The following drawing index sheet and reference drawings have been added to Volume 3.

DESIGN OF NEW STAIR FOR BETHESDA STATION - CONTRACT NO. 13-FQ1 0060-MCAP-19

RED LINE REHAB.-FRIENDSHIP HEIGHTS TO GROSVENOR - PART 6
PHASE 1B SECTIONS
SCALE AS SHOWN
DRAWING NO. A09-A-301
SHEET NO. M1272-195

SCALE AS SHOWN DRAWING NO. A10-G-102 SHEET NO. M1272-079

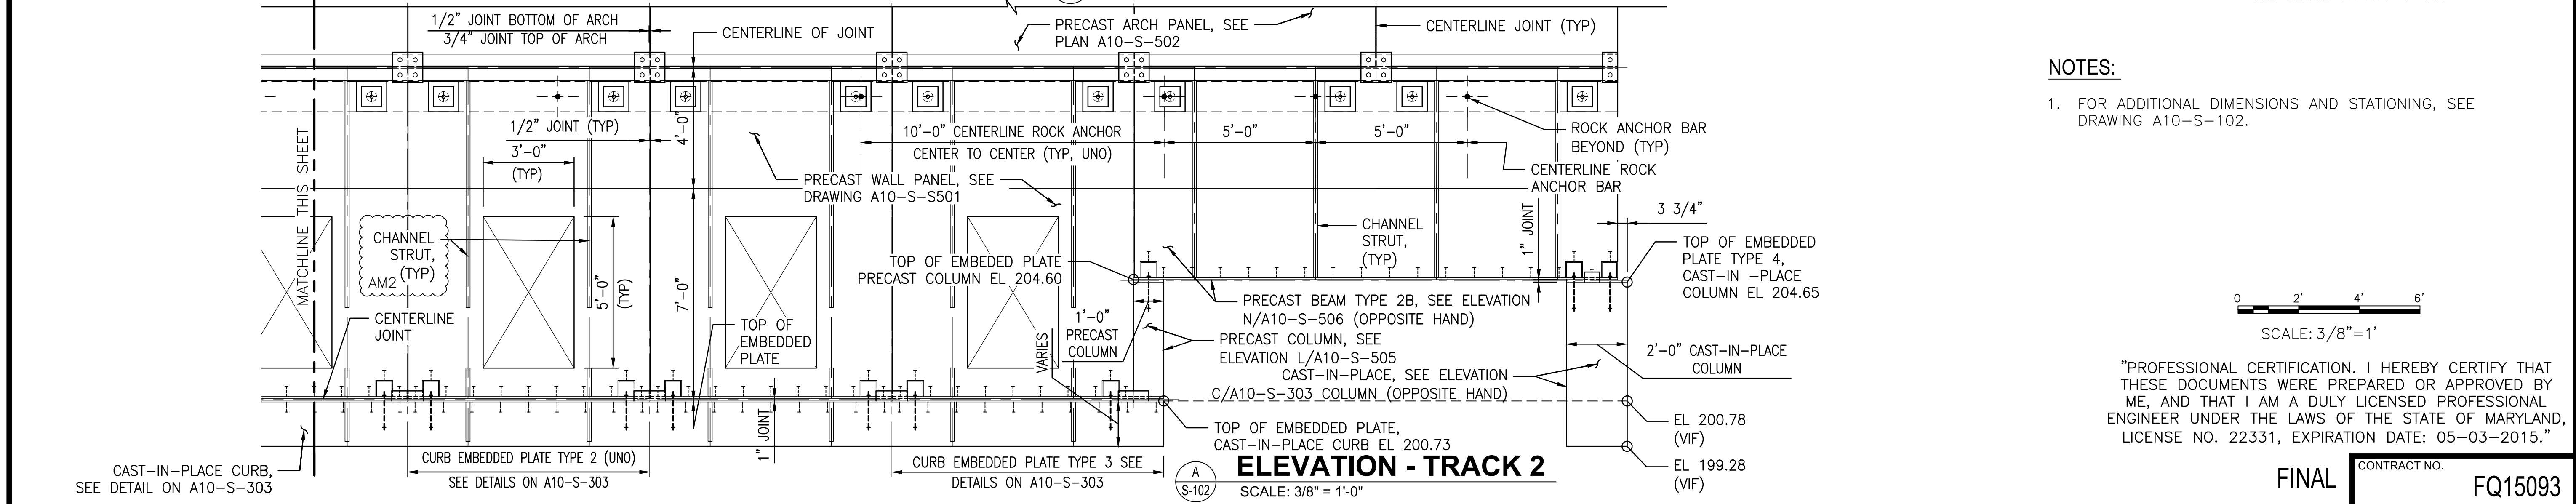
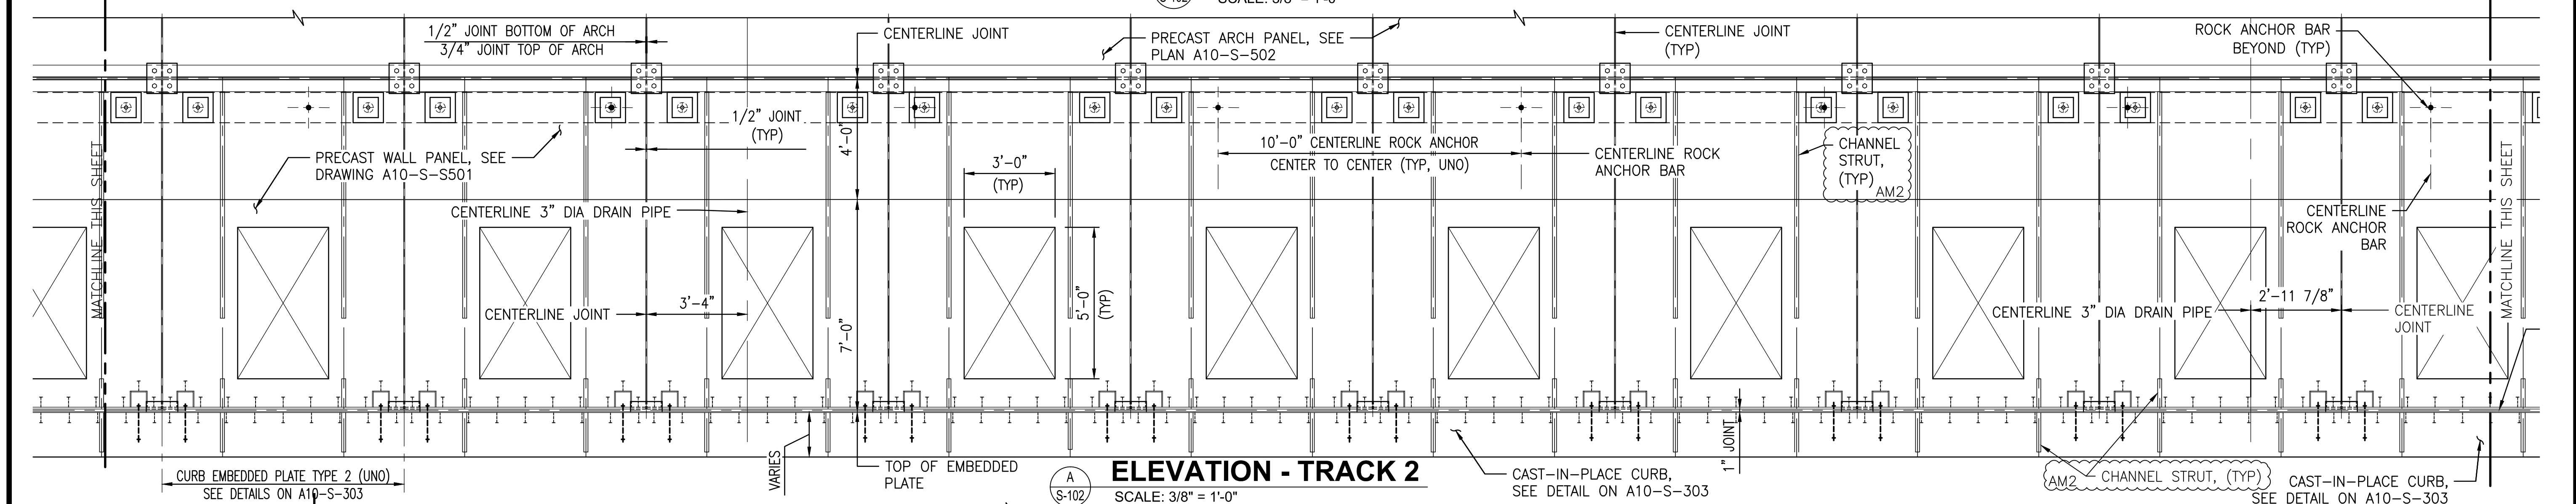
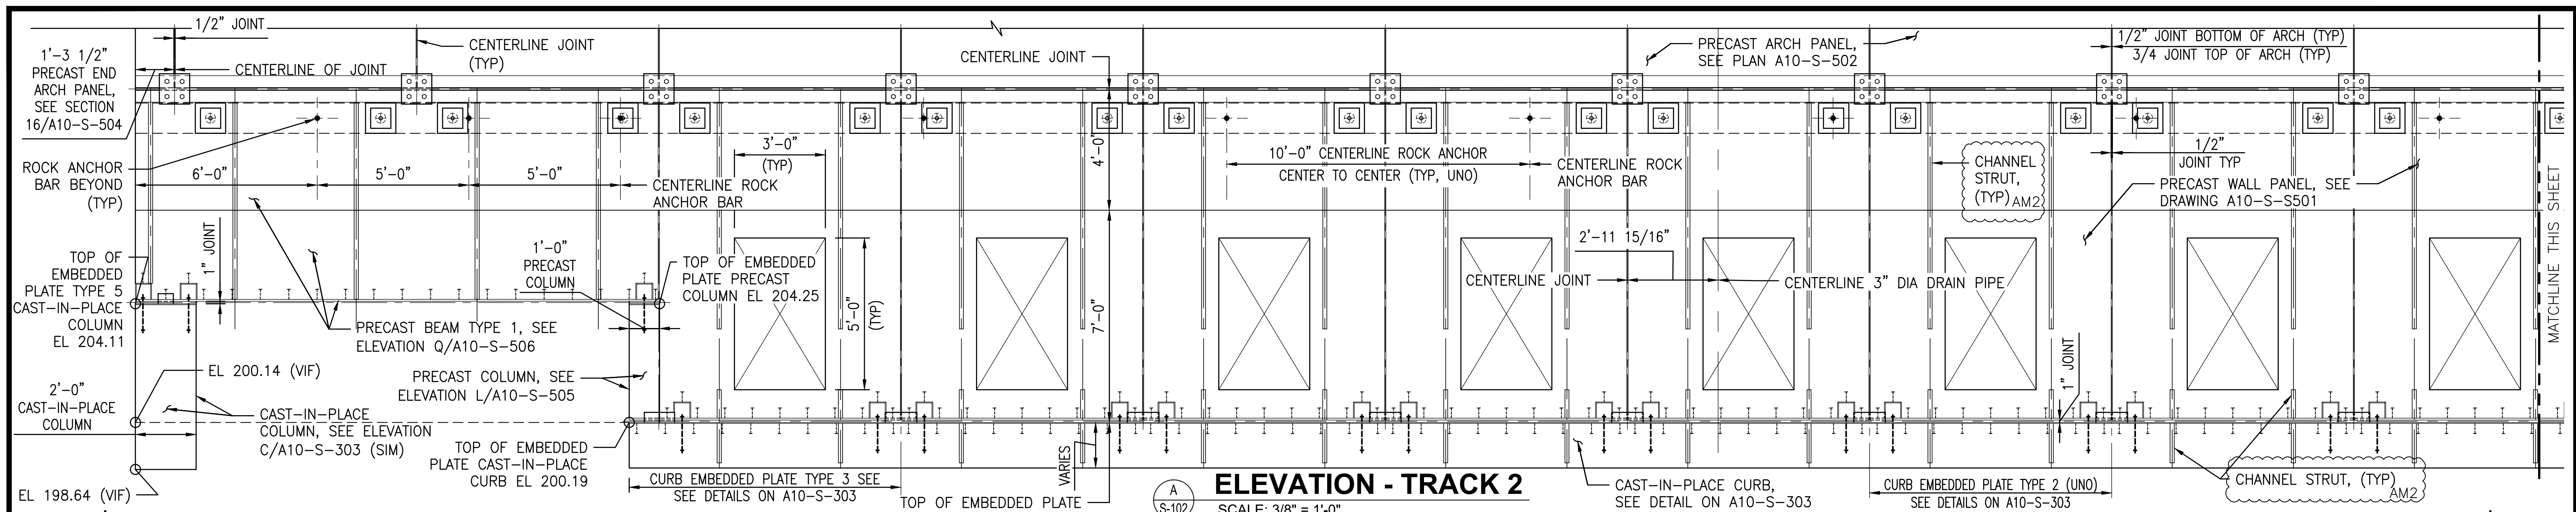
DESIGNED		DATE		REVISIONS	
NUMBER	DESCRIPTION	DATE	BY	DESCRIPTION	AM 2
01-15	M. VADOVIC	06-15	VC	REVISED NOTES	
01-15	P. GRUBB				
01-15	V. CECKA				
01-15	M. AVERSO

1. SEE EXISTING CABLE TEMPORARY PROTECTION DETAIL ON DWG G-101 FOR INFORMATION HOW TO PROTECT THE EXISTING AM2 CABLES DURING TIMES CONTRACTOR IS WORKING ON THE EXISTING WALL ABOVE. SEE EXISTING CABLE TEMPORARY PROTECTION DETAIL ON DWG G-101 FOR INFORMATION ON WHICH CABLES ARE TO BE RELOCATED TEMPORARILY BY CONTRACTOR TO 15 FEET ABOVE THE EXISTING SAFETY WALK PRIOR TO STARTING OF WORK INSIDE OF CROSSOVER AREA. NO EXISTING CABLES OR WIRES TO BE EMBEDDED IN THE SELF-CONSOLIDATING CONCRETE AREA. SEE PICTURES 1 AND PICTURE 2 ON DWG G-101 FOR GENERAL VIEW OF EXISTING WALLS. CONTRACTOR TO VERIFY THAT 15 FOOT HEIGHT IS ADEQUATE NOT TO INTERFERE WITH INSTALLATION OF PRECAST WALL PANELS. SEE NOTES 23 AND 30 BELOW. ALL THIS WORK NEEDS TO BE COORDINATED WITH THE AUTHORITY REPRESENTATIVE. EXISTING CABLES AND WIRES ARE LABELED IN THE FIELD AT EACH END OF CROSSOVERS.

8. REMOVE BUILDUP MATERIAL ON THE TOP OF EXISTING SAFETY WALK NEXT TO TRACK NO. 1. ALL BUILDUP MATERIAL MUST BE AM2 REMOVED DOWN TO SOUND CONCRETE BY MECHANICAL MEANS. POWER WASH THE EXISTING WALL TO 15 FEET ABOVE SAFETY WALK INCLUDING TOP OF EXISTING SAFETY WALK. DO NOT DAMAGE THE EXISTING CABLES THAT REMAIN ON THE WALL.

12. DRILL HOLES AND INSTALL HORIZONTAL ROCK ANCHOR BARS AND PLATES ON TRACK NO. 2 SIDE. GROUT AND TEST.
13. REMOVE BUILDUP MATERIAL ON THE TOP OF EXISTING SAFETY WALK NEXT TO TRACK NO. 2. ALL BUILDUP MATERIAL MUST BE AM2 REMOVED DOWN TO SOUND CONCRETE BY MECHANICAL MEANS. POWER WASH THE EXISTING WALL TO 15 FEET ABOVE SAFETY WALK INCLUDING TOP OF EXISTING SAFETY WALK. DO NOT DAMAGE THE EXISTING CABLES THAT REMAIN ON THE WALL. AM2

21. INSTALL PRECAST WALL PANELS; BOLT AND PLACE SELF-LEVELING CONCRETE TO TOP OF PRECAST WALL PANELS. START INSTALLING PRECAST WALL PANELS AT SOUTH END. IT IS RECOMMENDED TO PLACE CONCRETE IN LAYERS. CONTRACTOR MUST DEVELOP AND SUBMIT PLANS AND PROCEDURES FOR CABLE PROTECTION DURING PRECAST WALL ERECTION TO AUTHORITY REPRESENTATIVE FOR APPROVAL. AM2

SCALE AS SHOWN	DRAWING NO. A11-A-100	SHEET NO. M1272-144
----------------	-----------------------	---------------------

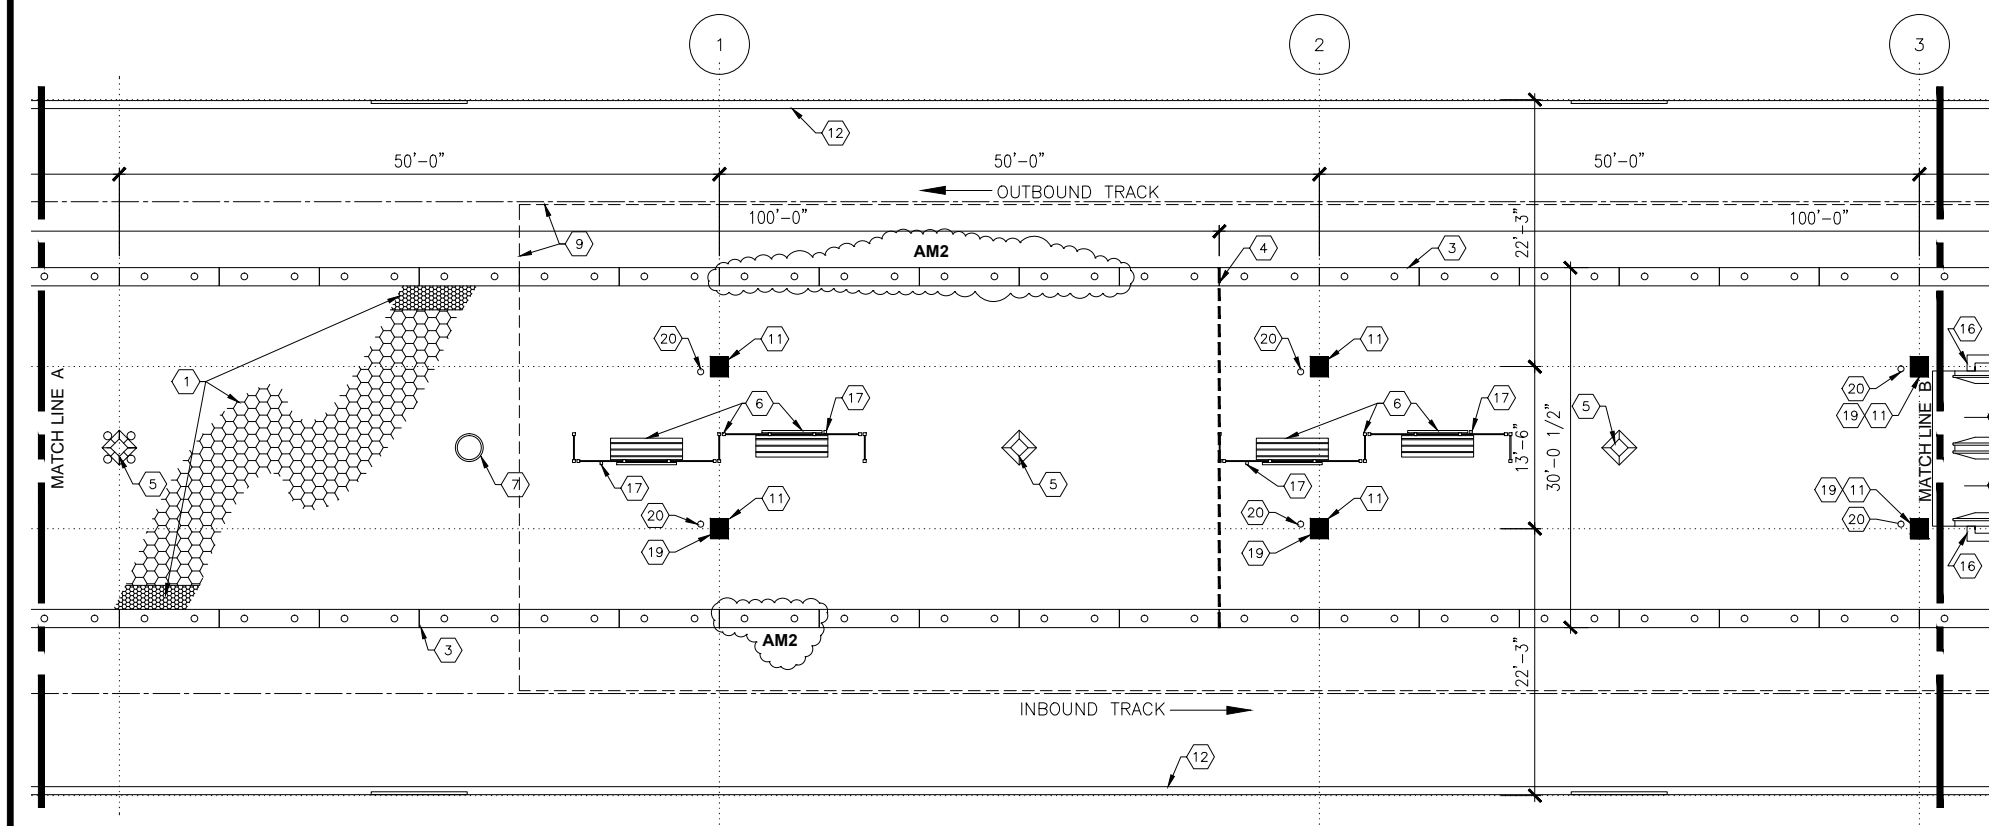
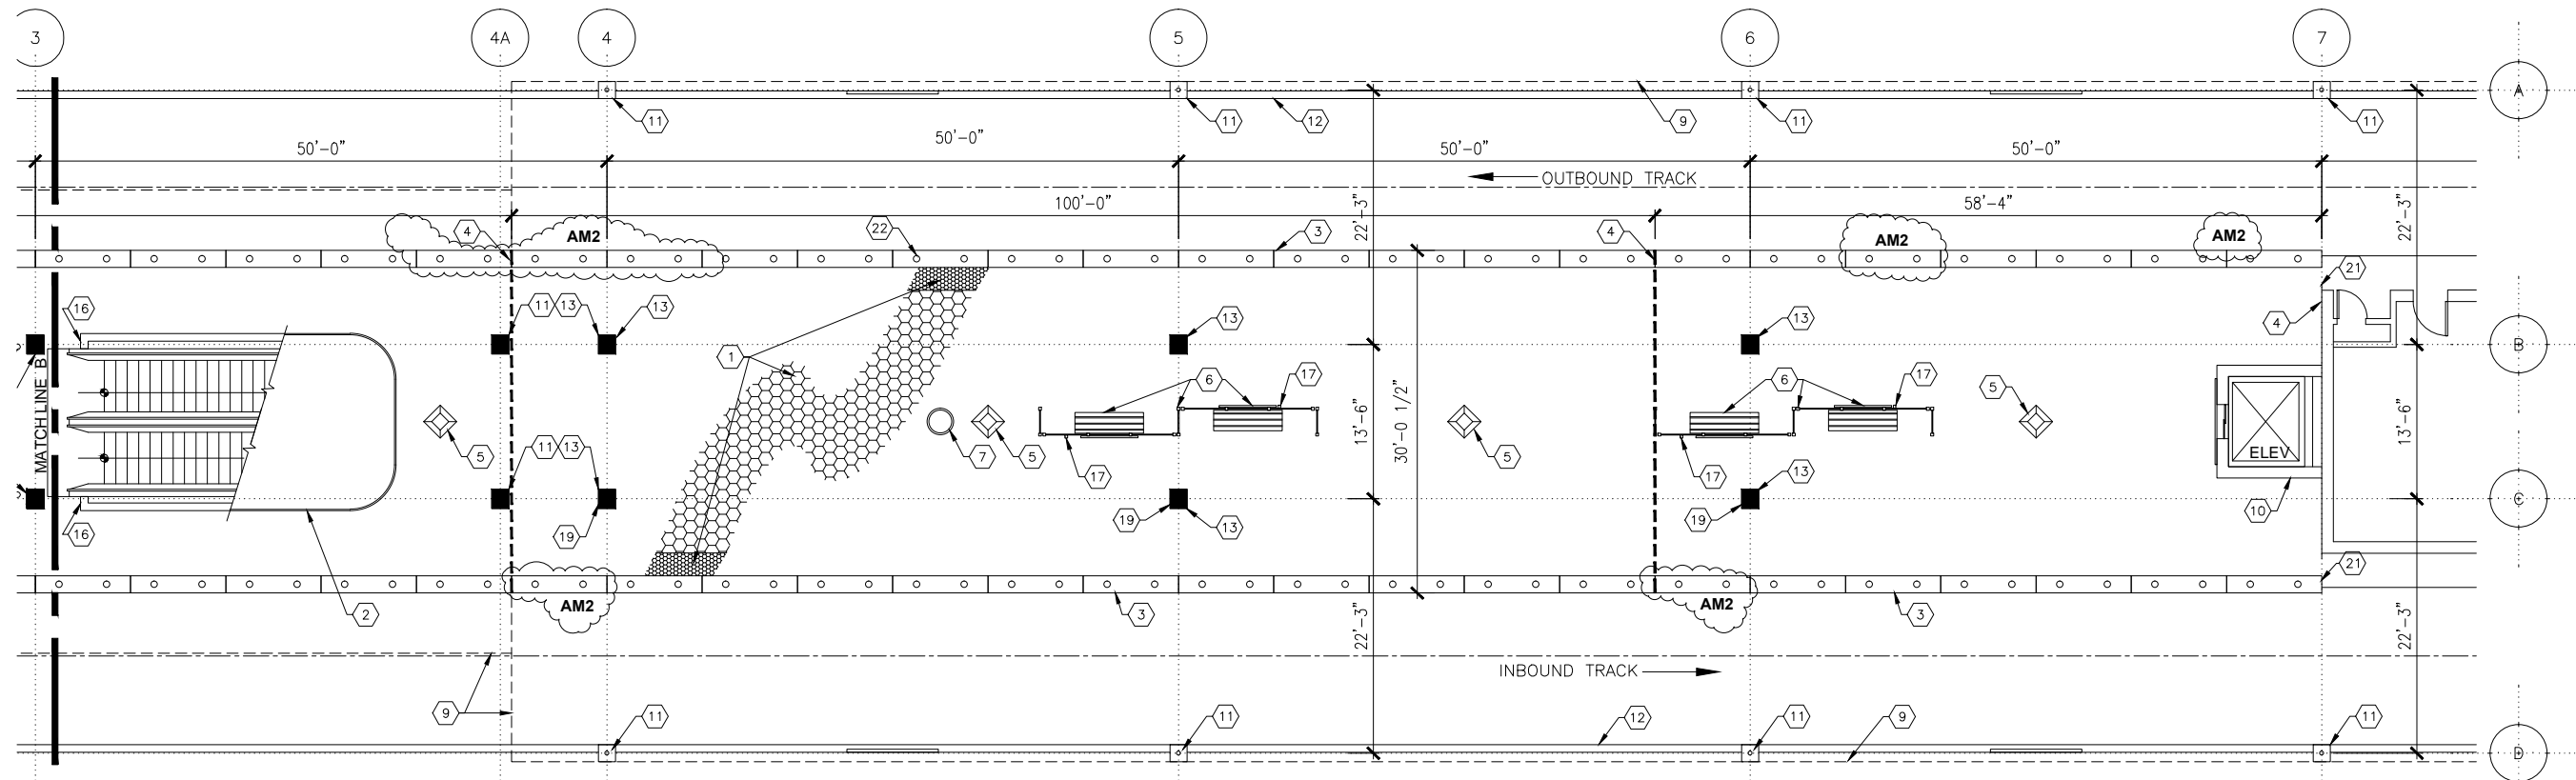
DESIGNED		DATE		NUMBER		DESCRIPTION		DATE		BY		REVISIONS		DESCRIPTION	
JRS	AD	RES	JP	4/30/14	7/16/14	7/22/14	7/28/14		6/19/15	C.R.					DEMO NOTE AND PLAN CHANGES AM2

- 3 CAREFULLY REMOVE EXISTING UNDAMAGED GRANITE EDGES AND GLASS LENSES ON BOTH DEMOLITION SHEETS AND STORE AT A LOCATION DESIGNATED BY A.R. DISPOSE OF DAMAGED GRANITE AND LENSES. **AM2**

- 12 EXIST RETAINING WALL. PROTECT AS REQUIRED DURING DEMOLITION.
- 13 EXIST CONC COLUMN. PROTECT AS REQUIRED DURING DEMOLITION.
- 14 DISPATCH OFFICE TO REMAIN. DO NOT REMOVE PLATFORM FINISHES. **AM2**

- 15 NOT USED **AM2**
- 16 PROTECT ESCALATOR AS REQUIRED FOR THE DURATION OF CONSTRUCTION.
- 17 REMOVE EXIST CONDUITS TO DIORAMAS AND REROUTE LOCATIONS OF NEW CONDUITS TO CENTER UNDER DIORAMAS. SEE ELECTRICAL DRAWINGS.

DRAWING NO. A11-A-101

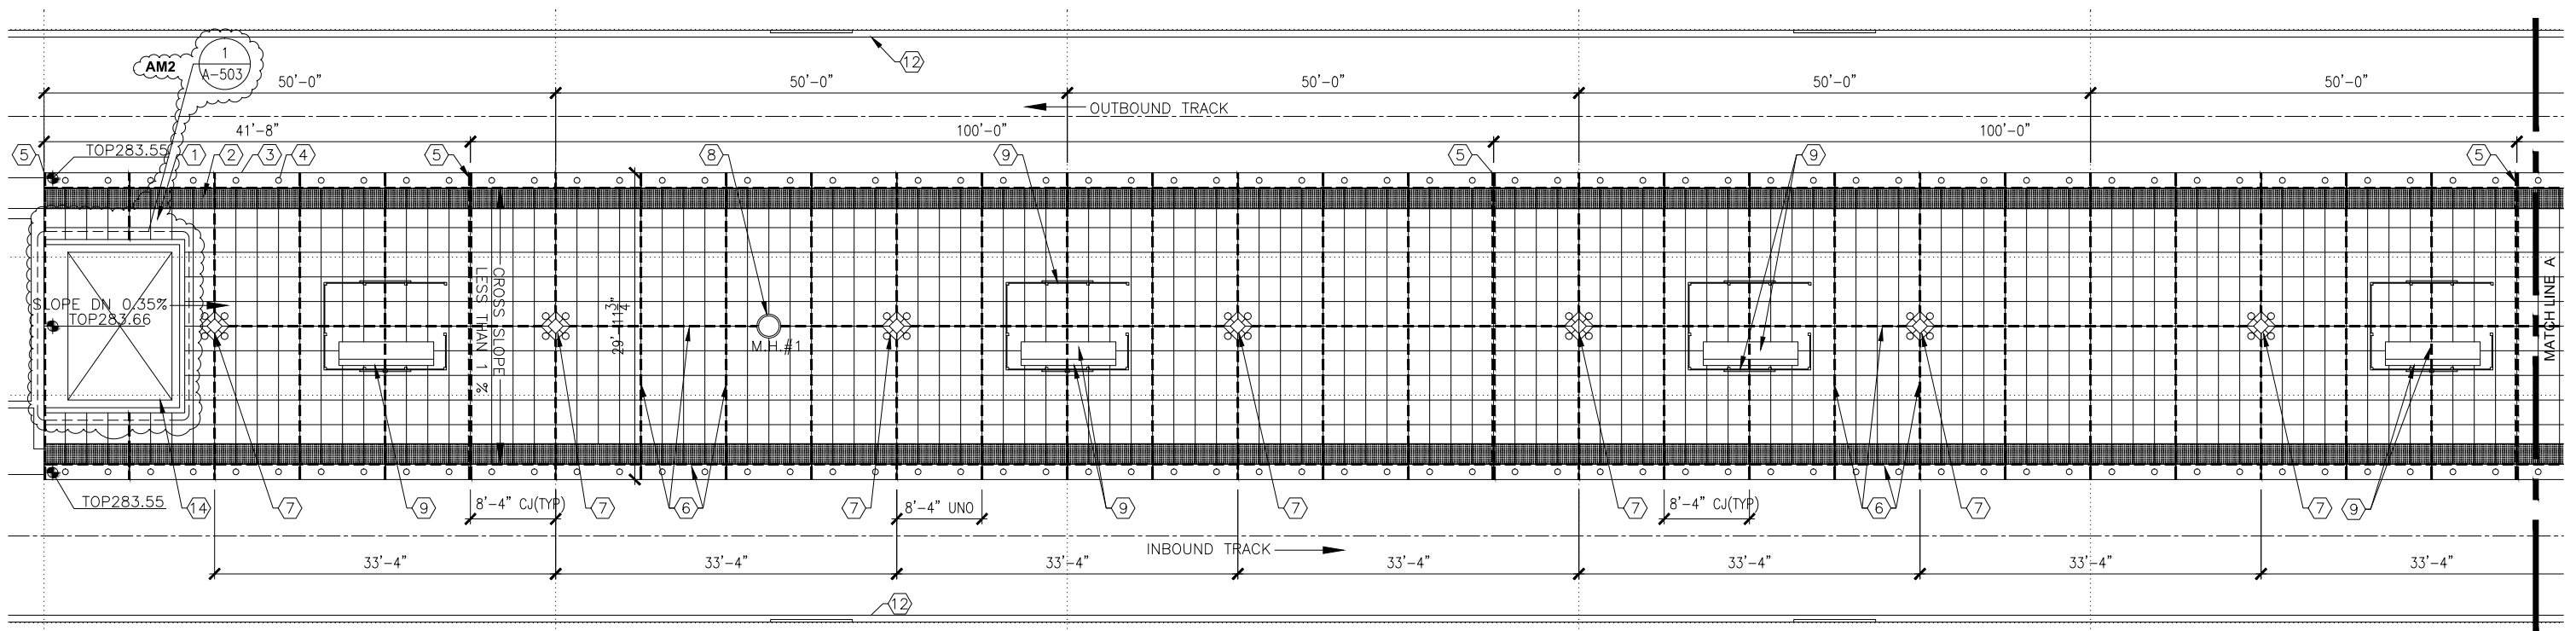
DESIGNED		DATE		REFERENCE DRAWINGS		REVISIONS	
NUMBER	DESCRIPTION	DATE	BY	NUMBER	DESCRIPTION	DATE	BY
JRS	4/30/14						
AD	7/16/14						
RES	7/22/14						
JP	7/28/14						
		6/19/15	C.R.		DEMO NOTE AND PLAN CHANGES		AM2

- CAREFULLY REMOVE EXISTING UNDAMAGED GRANITE EDGES AND GLASS LENSES ON BOTH DEMOLITION SHEETS AND STORE AT A LOCATION DESIGNATED BY A.R. DISPOSE OF DAMAGED GRANITE AND LENSES. **AM2**

- EXIST RETAINING WALL. PROTECT AS REQUIRED DURING DEMOLITION.
- EXIST CONC COLUMN. PROTECT AS REQUIRED DURING DEMOLITION.
- DISPATCH OFFICE TO REMAIN. DO NOT REMOVE PLATFORM FINISHES. **AM2**

- NOT USED **AM2**
- PROTECT ESCALATOR AS REQUIRED FOR THE DURATION OF CONSTRUCTION.
- REMOVE EXIST CONDUITS TO DIORAMAS AND REROUTE LOCATIONS OF NEW CONDUITS TO CENTER UNDER DIORAMAS. SEE ELECTRICAL DRAWINGS.
